ESC Comment Responses shown in this style.

MEADOW POINT CONDOMINIUMS SITE PLAN AMENDMENT

COVER SHEET
THE PEAK AT MEADOW POINT SITE PLAN
4470 SOUTH PITKIN STREET
LOT 1, BLOCK 1, THE PEAK AT MEADOW POINT SUBDIVISION
FILING NO. 1
CITY OF AURORA, COUNTY OF ARAPAHOE, STATE OF COLORADO

OVERALL SITE PLAN
THE PEAK AT MEADOW POINT SITE PLAN
4470 SOUTH PITKIN STREET
LOT 1, BLOCK 1, THE PEAK AT MEADOW POINT SUBDIVISION
FILING NO. 1
CITY OF AURORA, COUNTY OF ARAPAHOE, STATE OF COLORADO

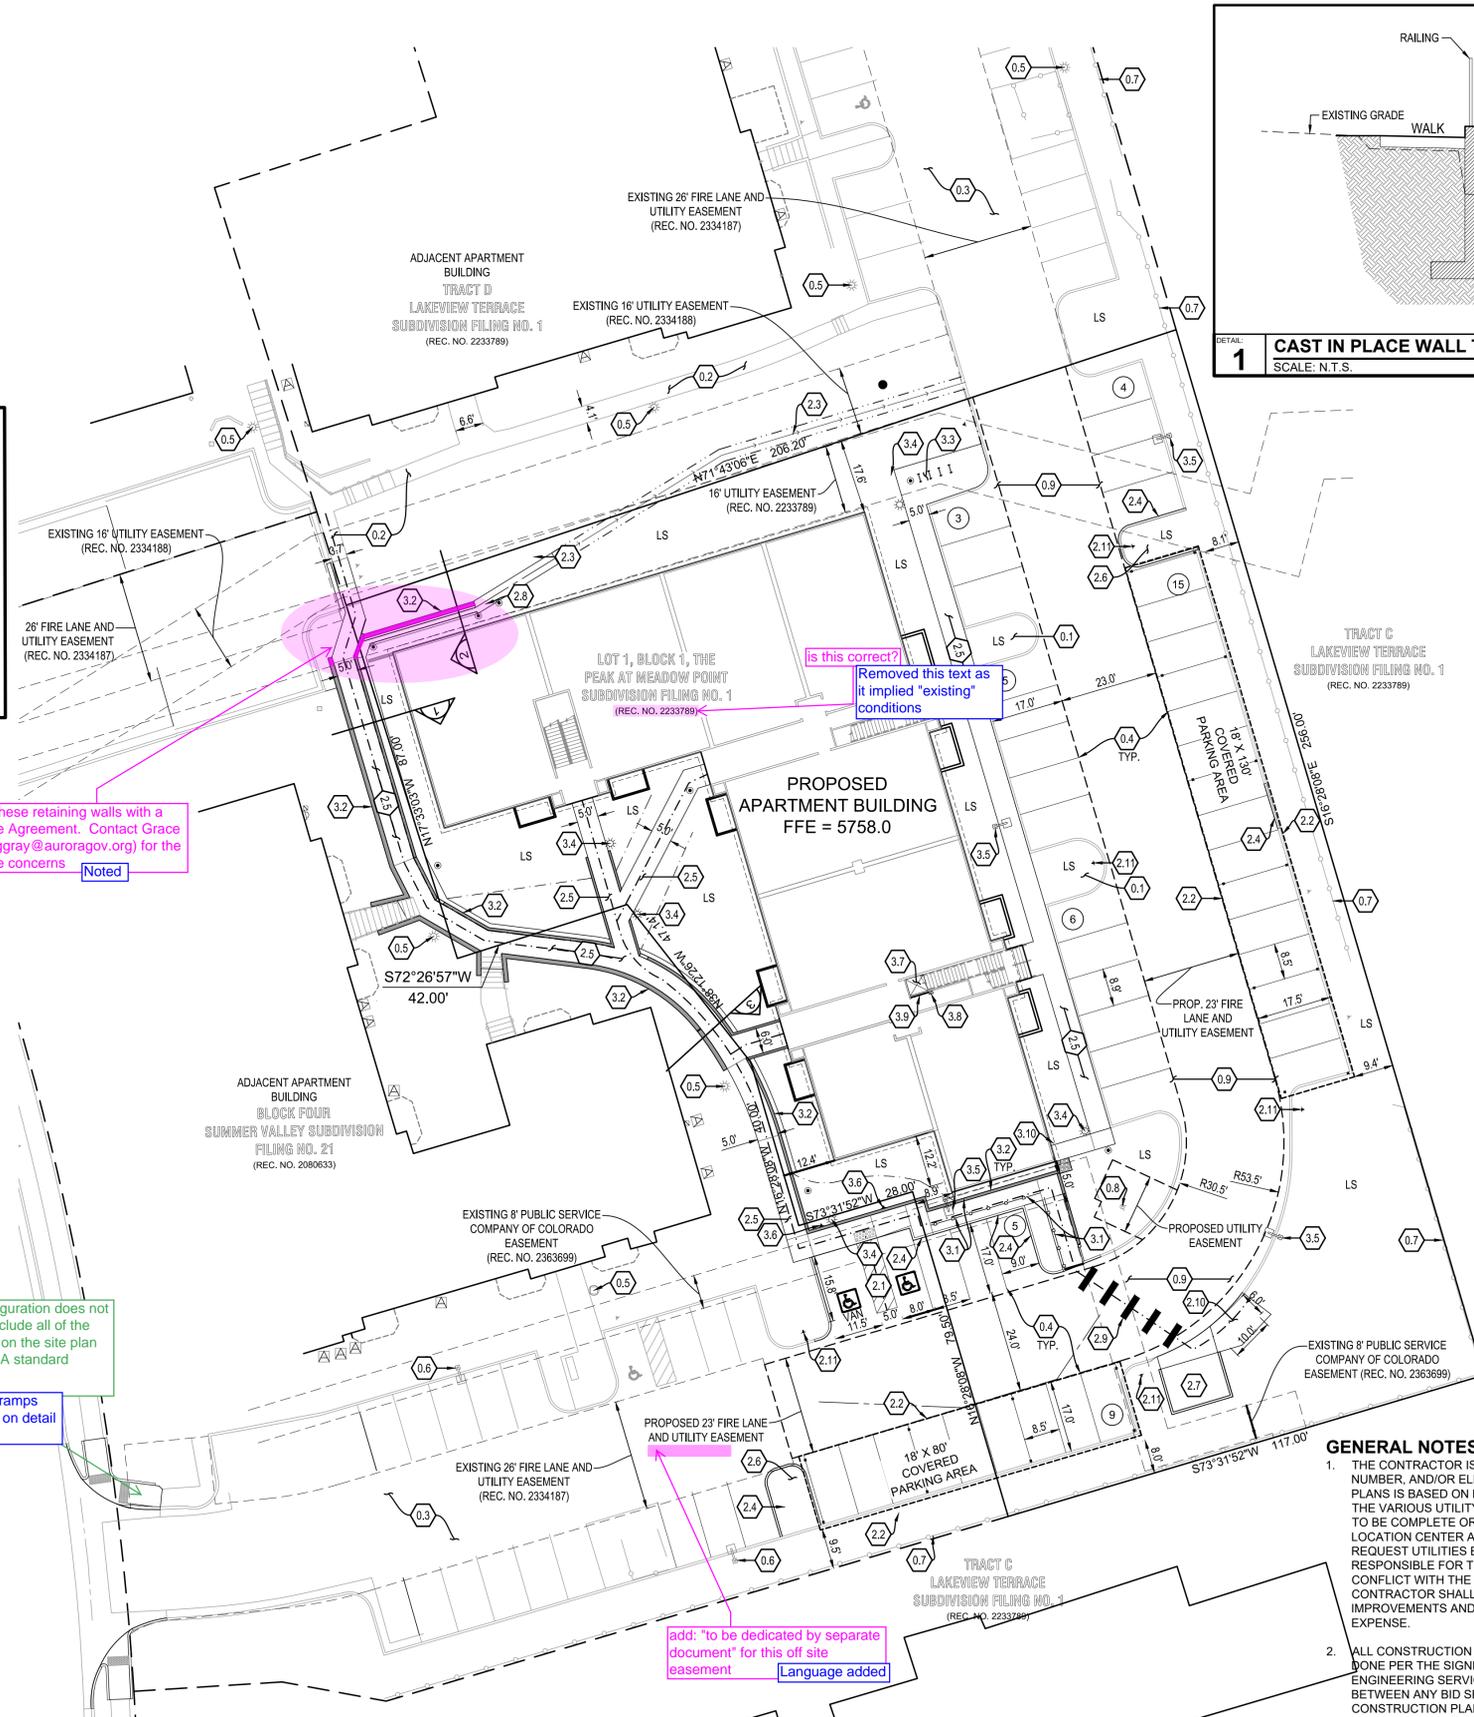
cover these retaining walls with a License Agreement. Contact Grace Gray (ggray@auroragov.org) for the License concerns **Noted**

This ramp configuration does not work. Please include all of the updated ramps on the site plan and refer to COA standard details
All 3 updated ramps shown in plan on detail sheet now

is this correct?
Removed this text as it implied "existing" conditions

add: "to be dedicated by separate document" for this off site easement **Language added**

UTILITY AND GRADING PLAN
THE PEAK AT MEADOW POINT SITE PLAN
4470 SOUTH PITKIN STREET
LOT 1, BLOCK 1, THE PEAK AT MEADOW POINT SUBDIVISION
FILING NO. 1
CITY OF AURORA, COUNTY OF ARAPAHOE, STATE OF COLORADO

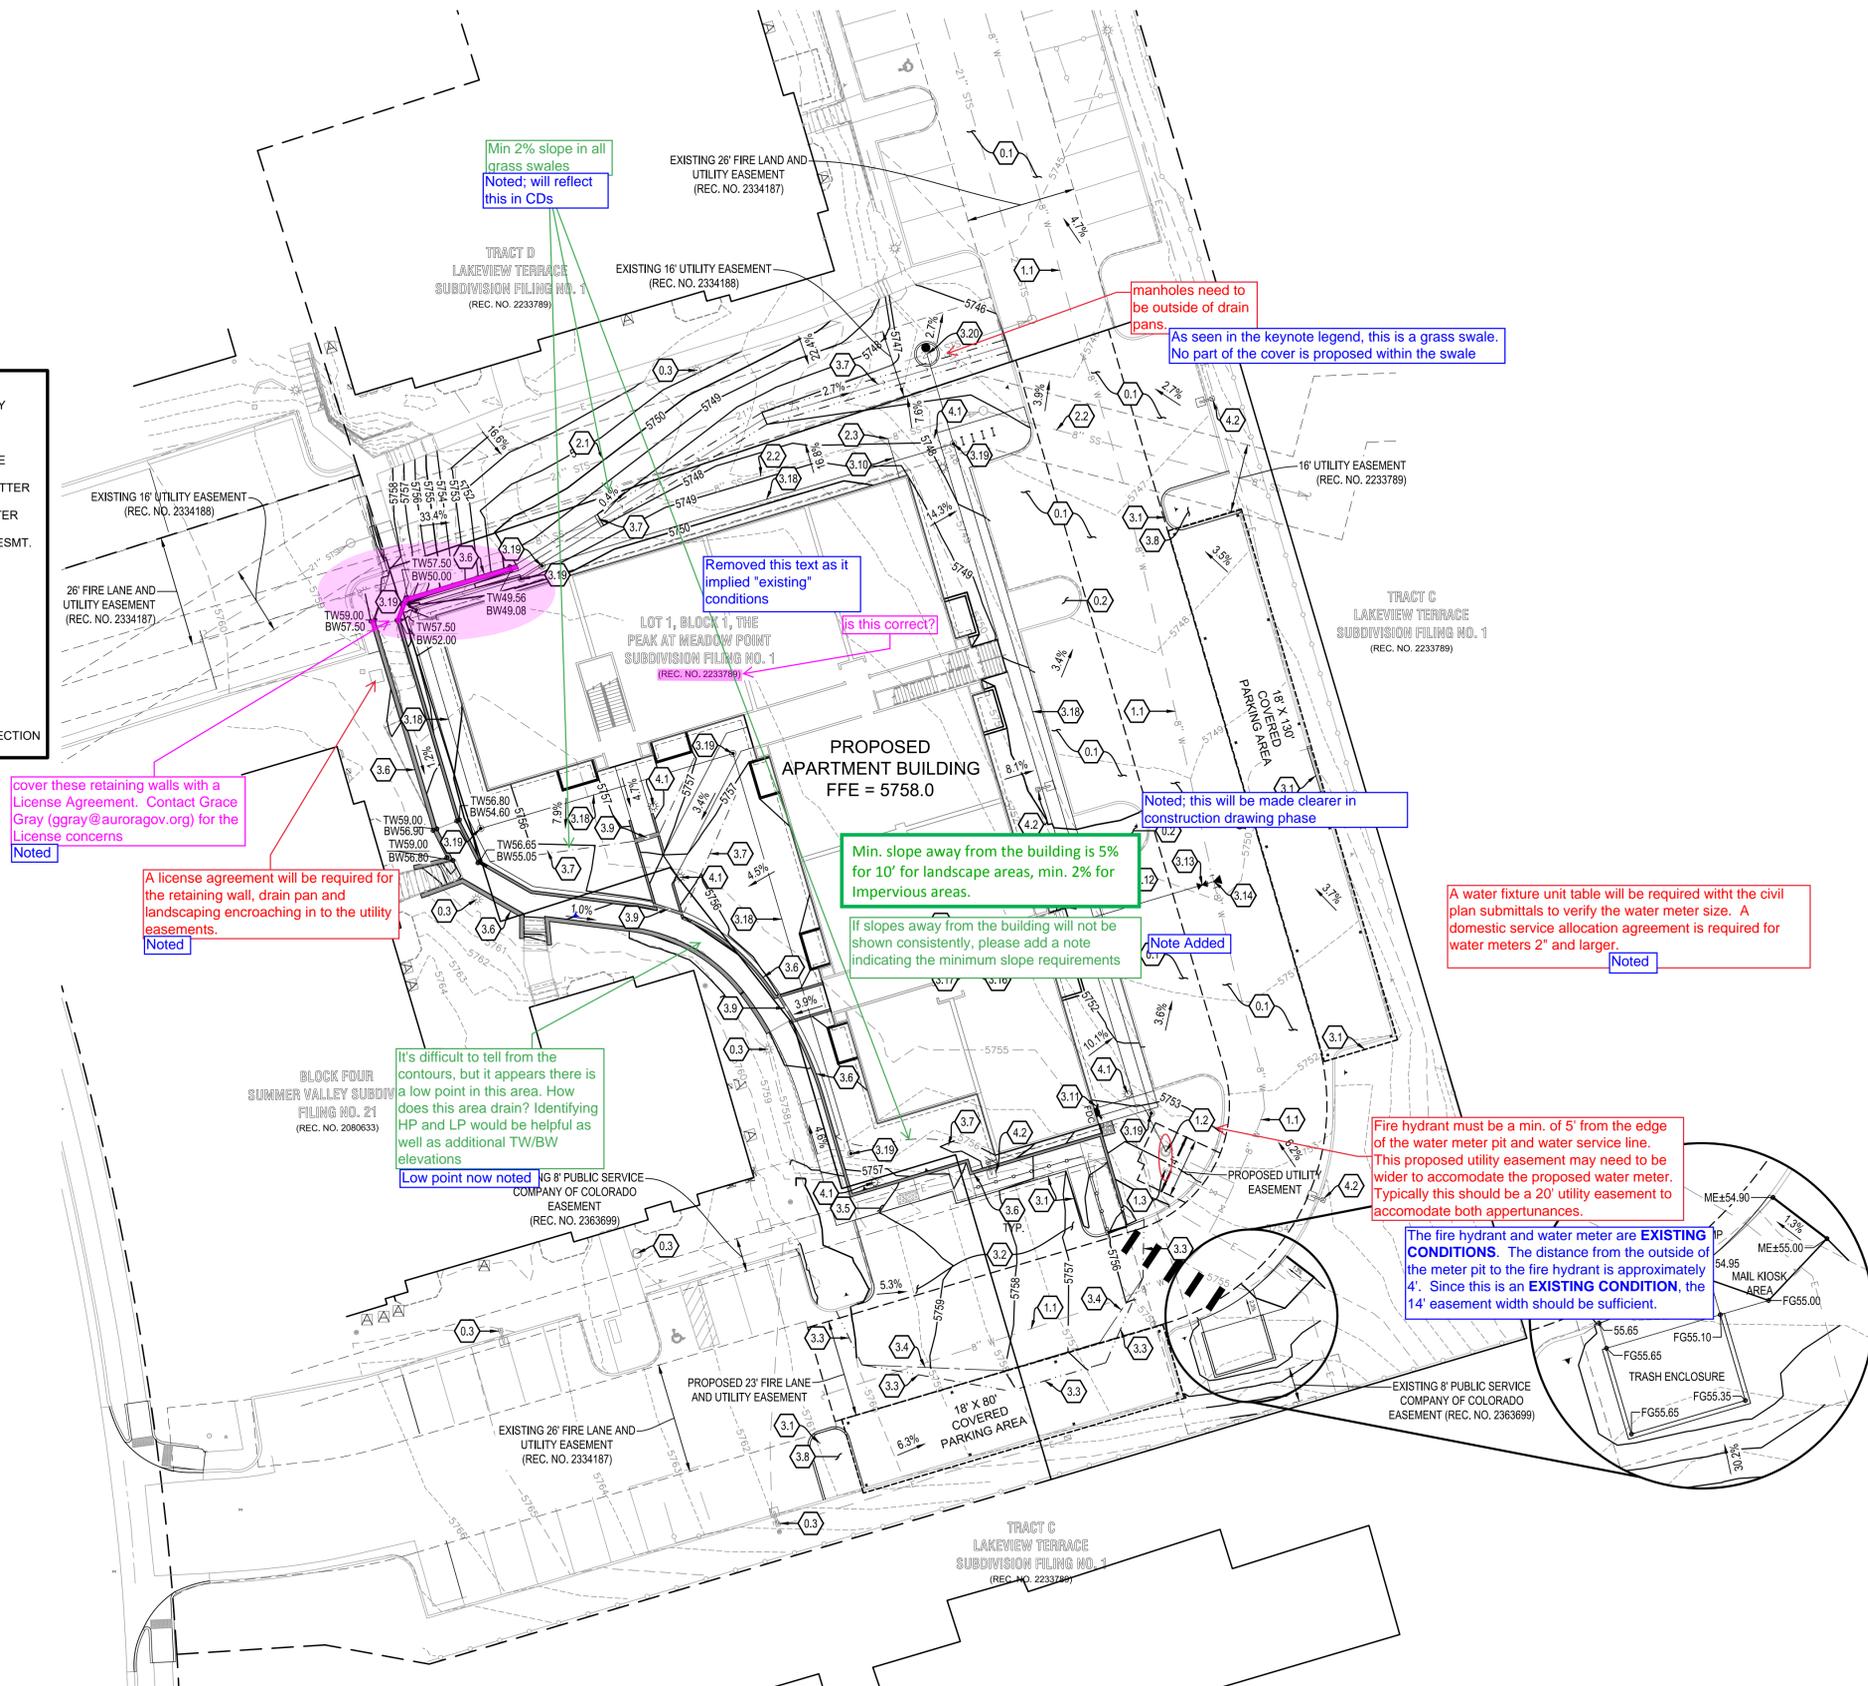
The site plan will not be approved by public works until the preliminary drainage letter/report is approved

DETAILS
THE PEAK AT MEADOW POINT SITE PLAN
4470 SOUTH PITKIN STREET
LOT 1, BLOCK 1, THE PEAK AT MEADOW POINT SUBDIVISION
FILING NO. 1
CITY OF AURORA, COUNTY OF ARAPAHOE, STATE OF COLORADO

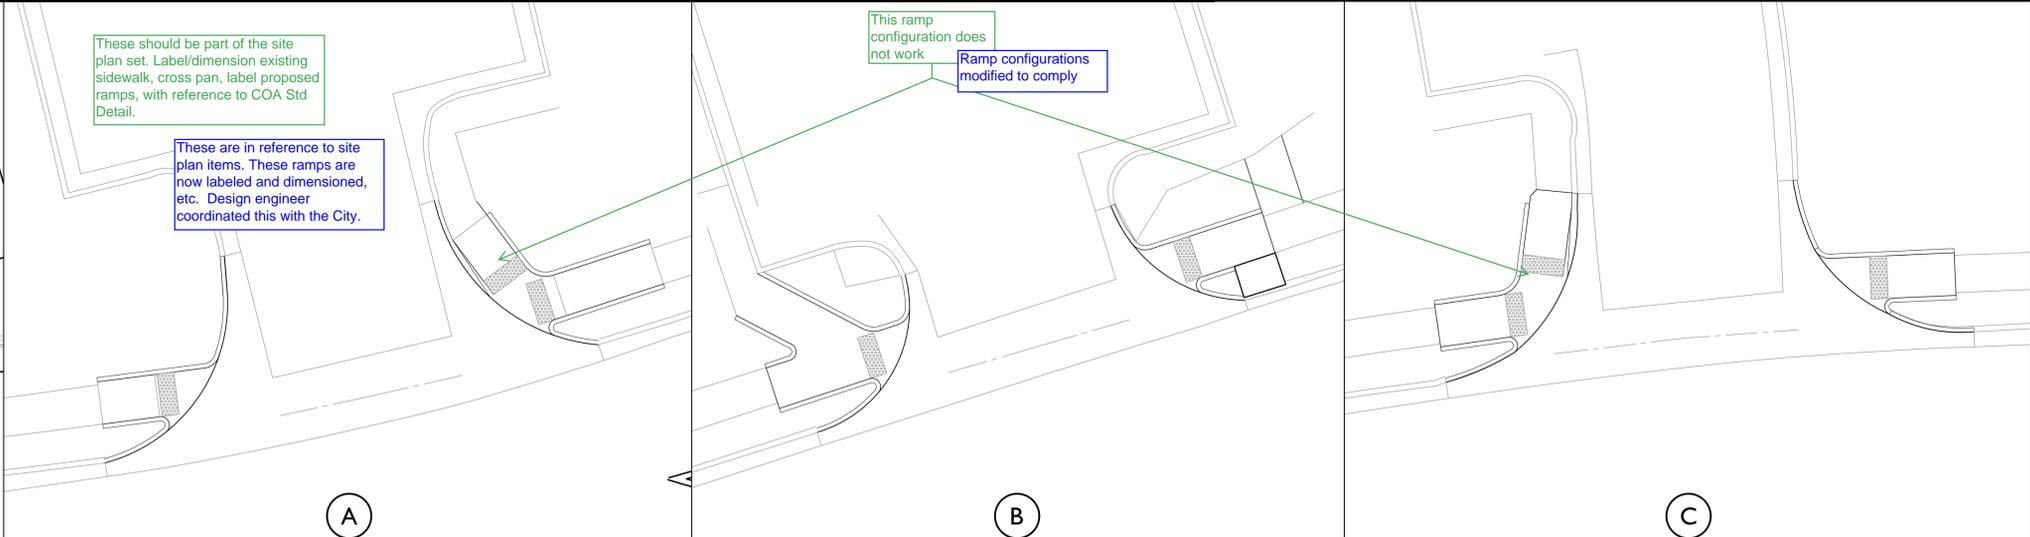
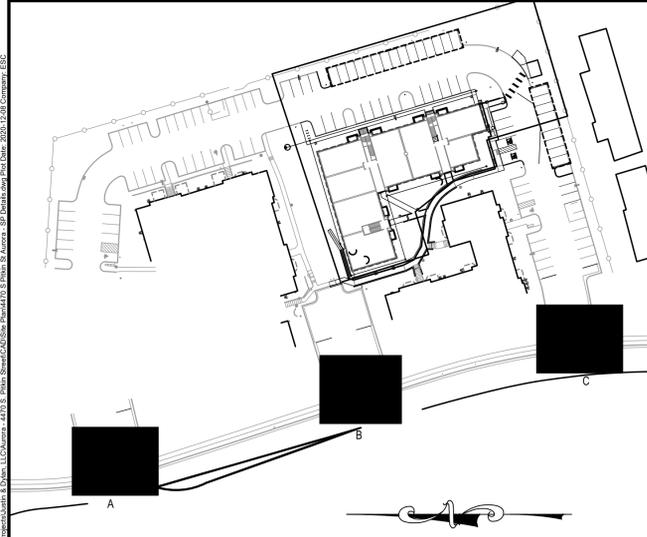
Include the existing and proposed grading grayed back.

LANDSCAPE PLAN
THE PEAK AT MEADOW POINT SITE PLAN
4470 SOUTH PITKIN STREET
LOT 1, BLOCK 1, THE PEAK AT MEADOW POINT SUBDIVISION
FILING NO. 1
CITY OF AURORA, COUNTY OF ARAPAHOE, STATE OF COLORADO

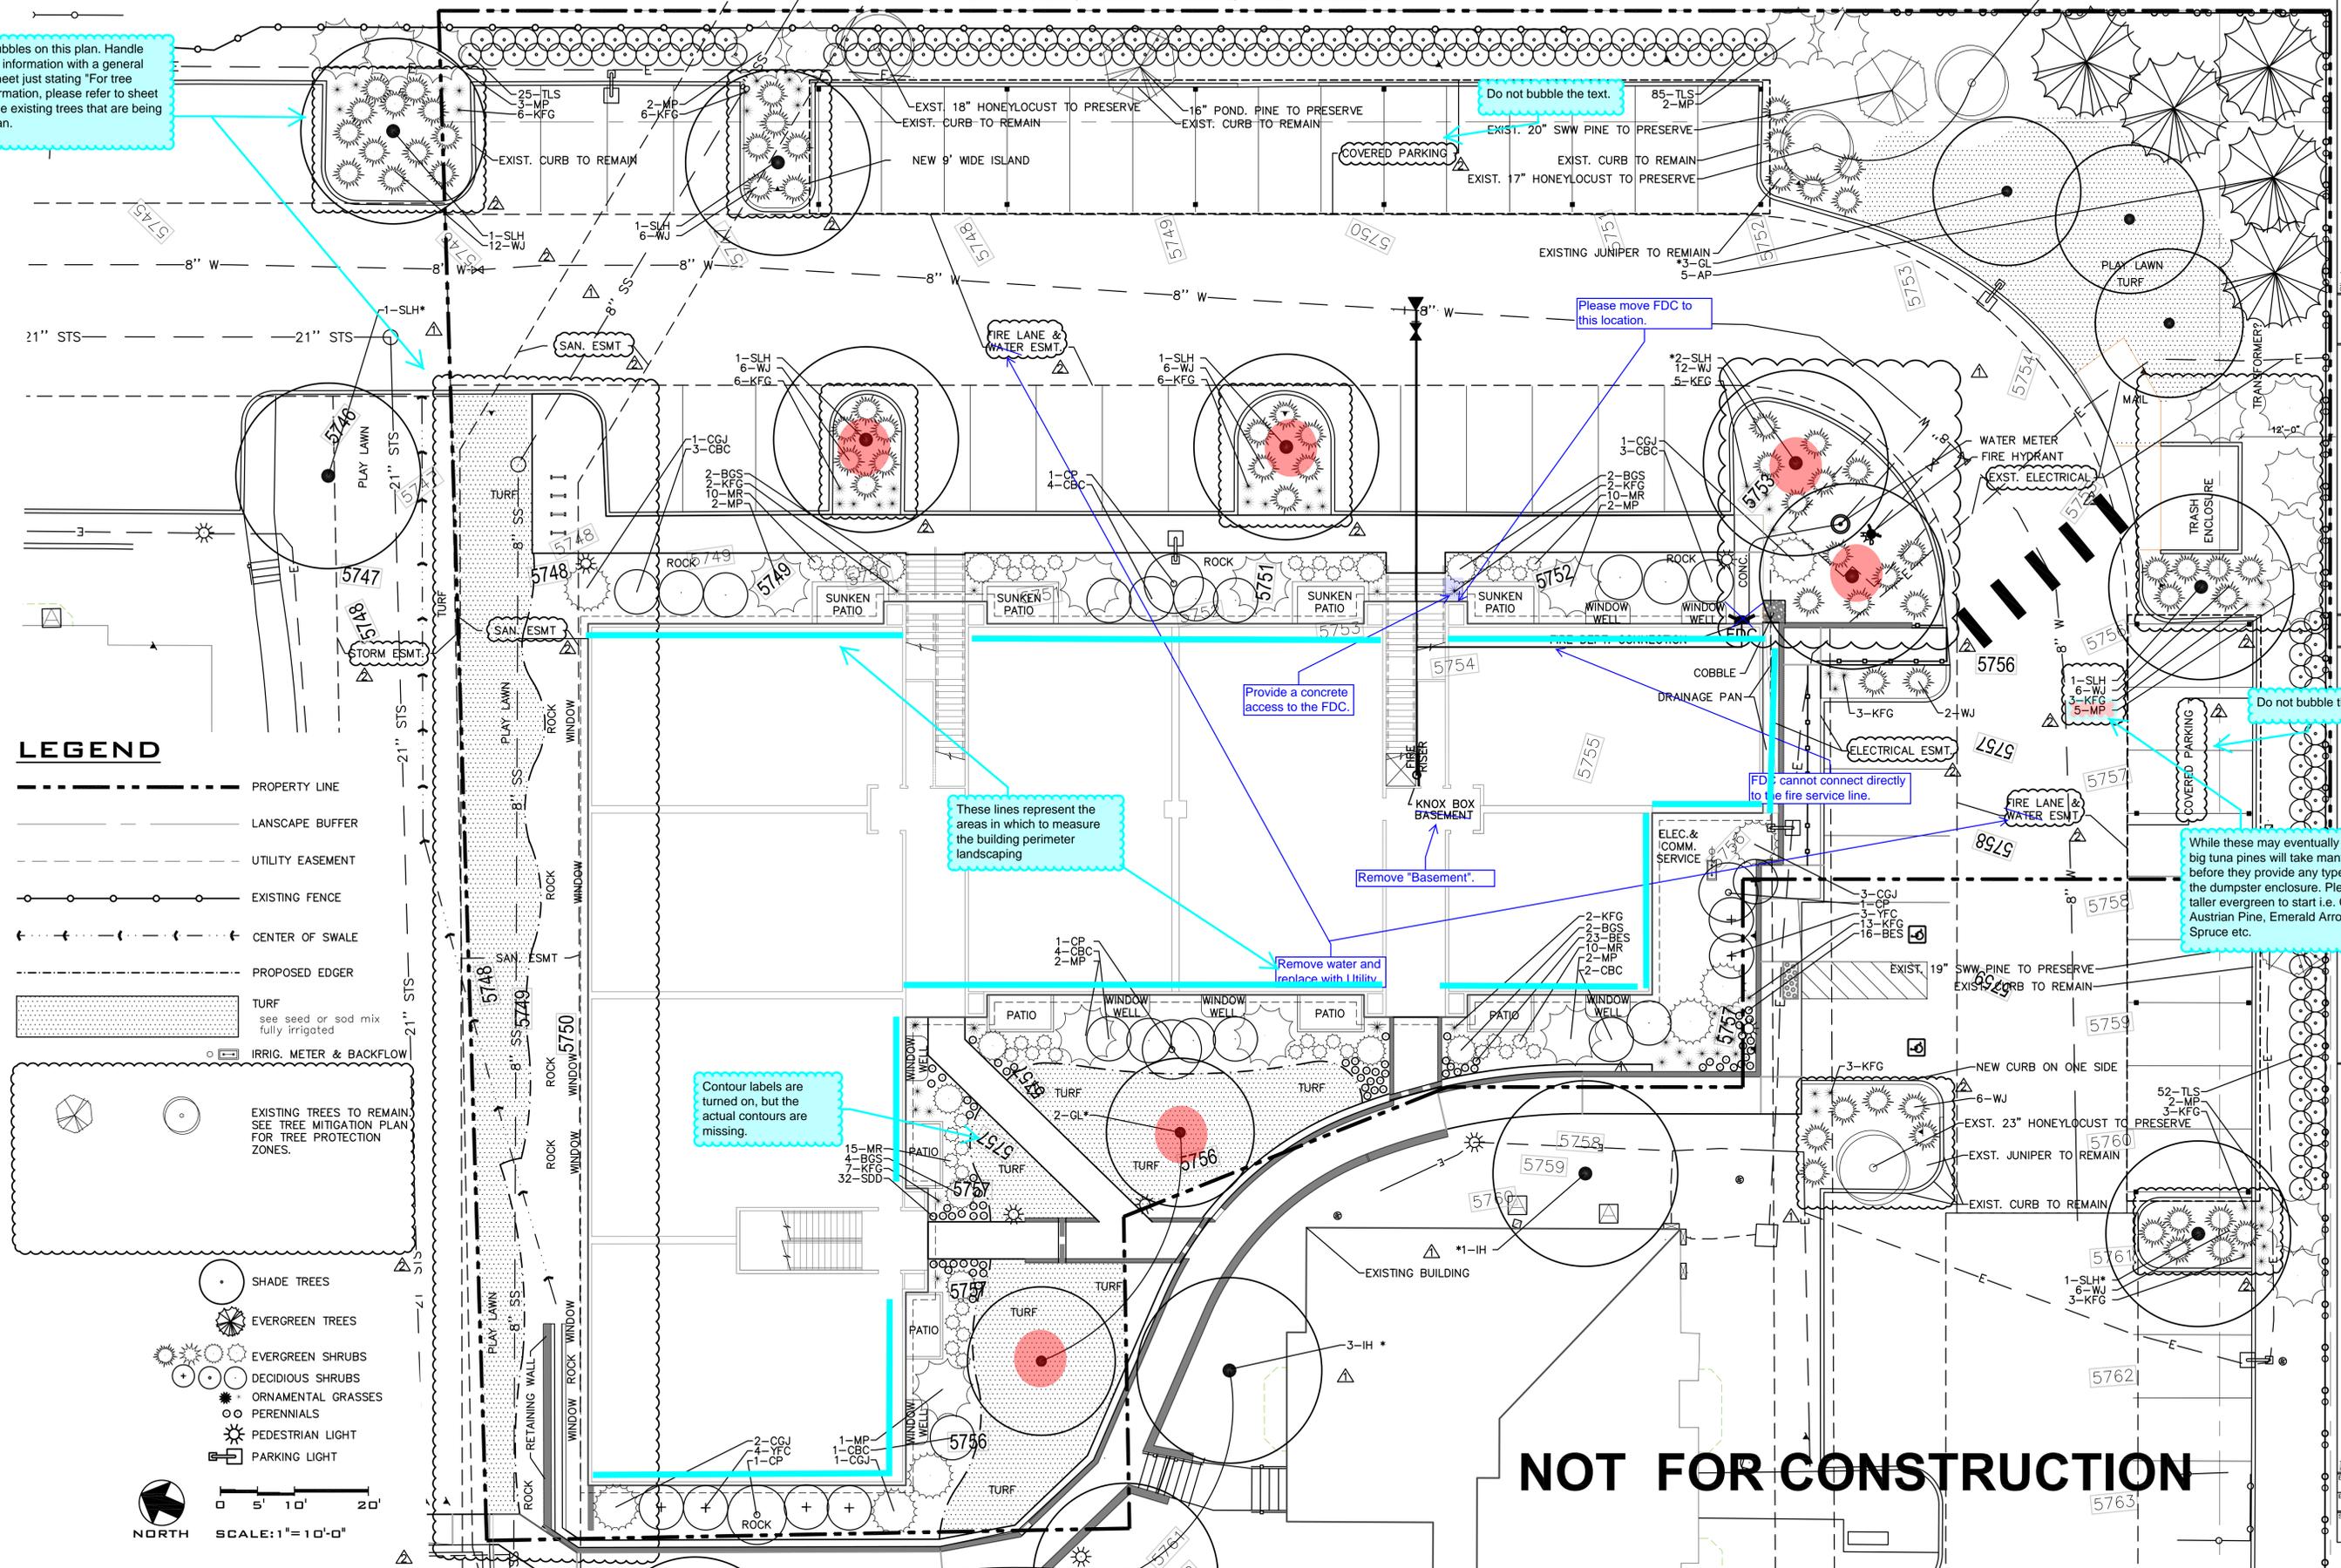
Turn off the bubbles on this plan. Handle tree mitigation information with a general note on this sheet just stating "For tree mitigation information, please refer to sheet X. Still keep the existing trees that are being kept on the plan."

Do not bubble the text.

Please move FDC to this location.

Provide a concrete access to the FDC.

These lines represent the areas in which to measure the building perimeter landscaping

Remove "Basement".

Remove water and replace with utility.

Contour labels are turned on, but the actual contours are missing.

Do not bubble the text.

While these may eventually get tall, these big tuna pines will take many, many years before they provide any type of screening of the dumpster enclosure. Please provide a taller evergreen to start i.e. Columnar Austrian Pine, Emerald Arrow, Fastigiata Spruce etc.
